January 31, 1979

Dockets Nos.: 50-313 ✓
and 50-368

On November 13, 1978, the Commission issued Amendments Nos. 37 and 5 to Facility Operating Licenses Nos. DPR-51 and NPF-6 for Arkansas Nuclear One, Units Nos. 1 and 2 (ANO-1 & 2), respectively.

- Page 5-9 (Figure No. 5-1)
for ANO-1, License No. DPR-51
- Page 5-10 (Figure No. 5-1)
for ANO-2, License No. NPF-6

FIG. NO.
5-1

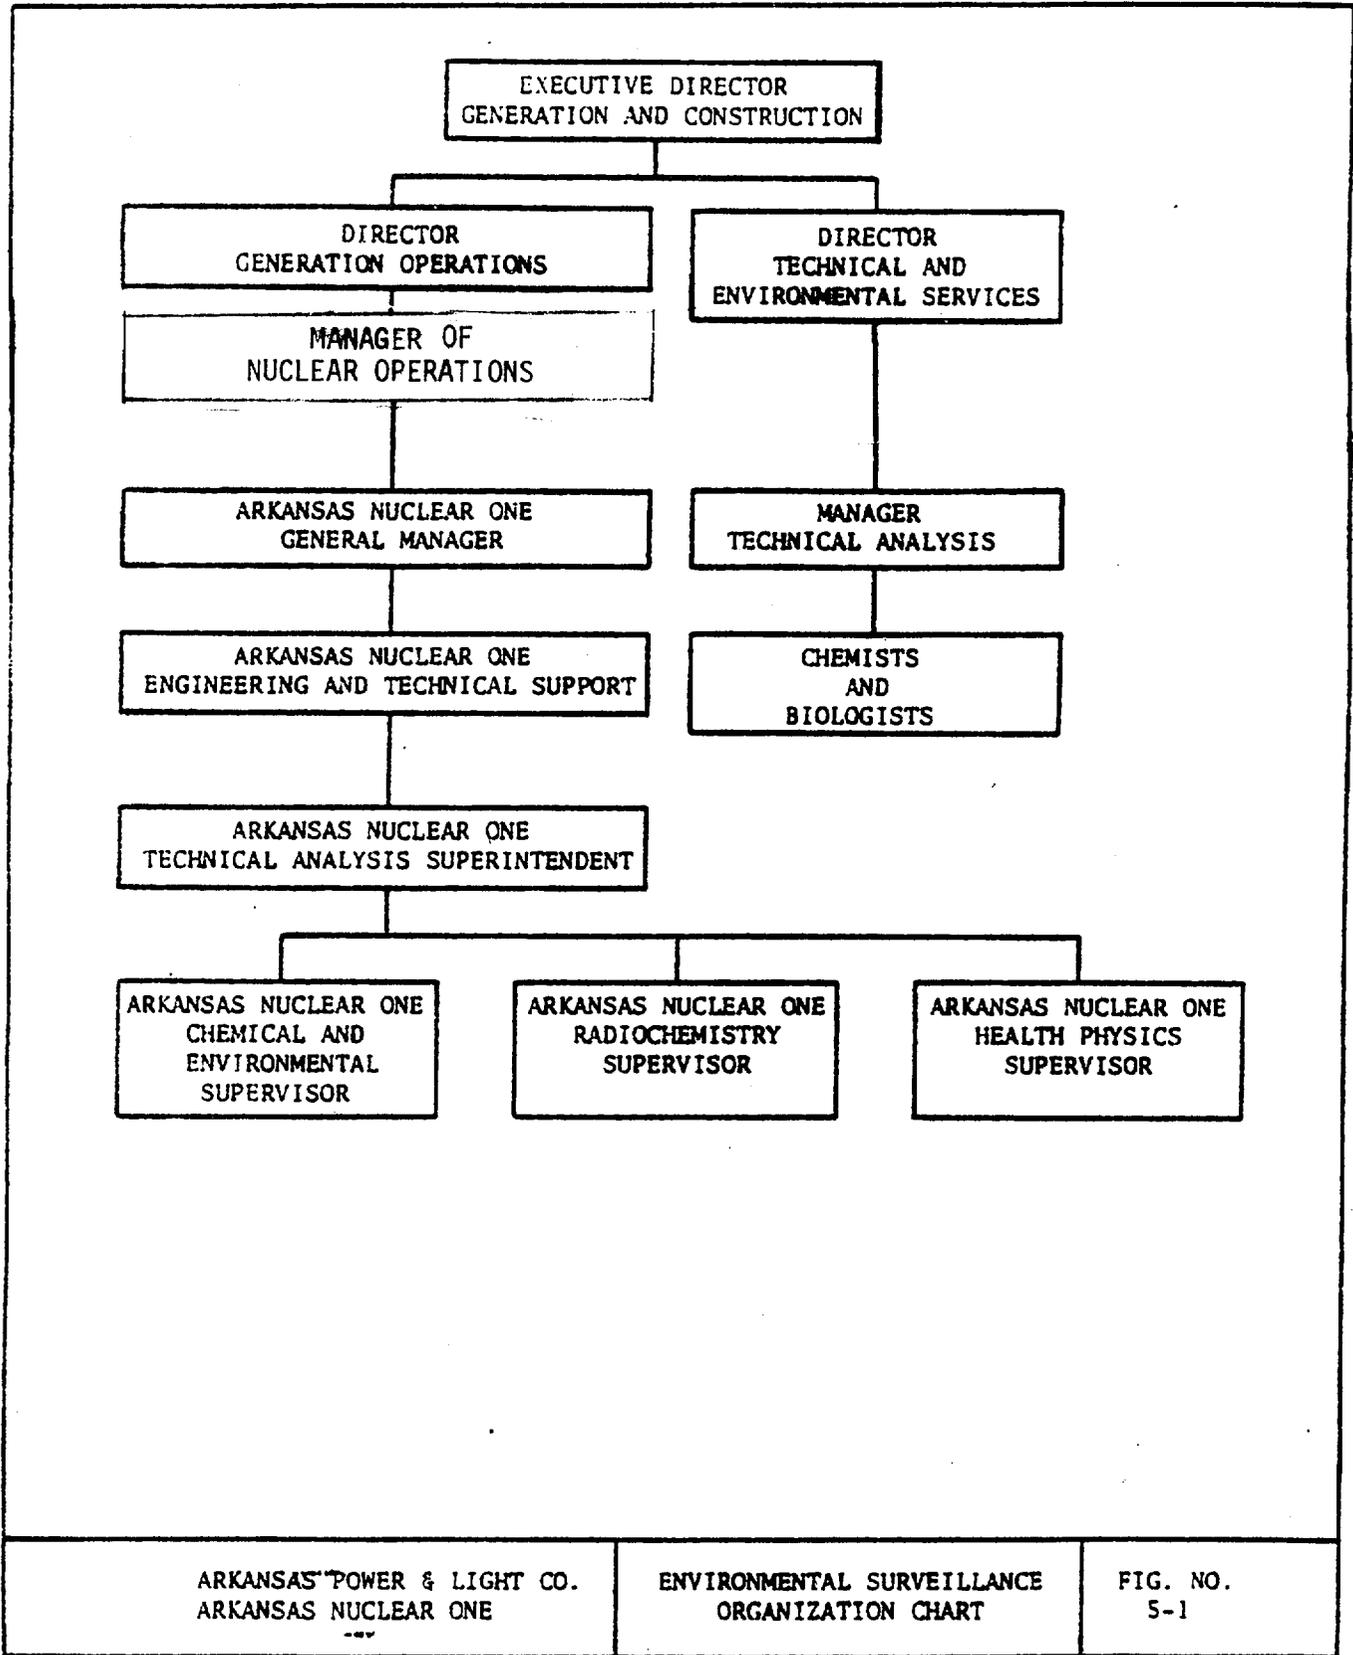
These amendments modified the Technical Specifications dealing with the plant organization structure and revised the ANO-1 Administrative Controls of the Environmental Technical Specifications to make them current and consistent with ANO-2. However, the position of "Manager of Nuclear Operations" was inadvertently omitted from Figure No. 5-1, "Environmental Surveillance Organization Chart," of the Environmental Technical Specifications for ANO-1 & 2.

We have corrected this error and have enclosed revised pages for insertion in your Technical Specifications.
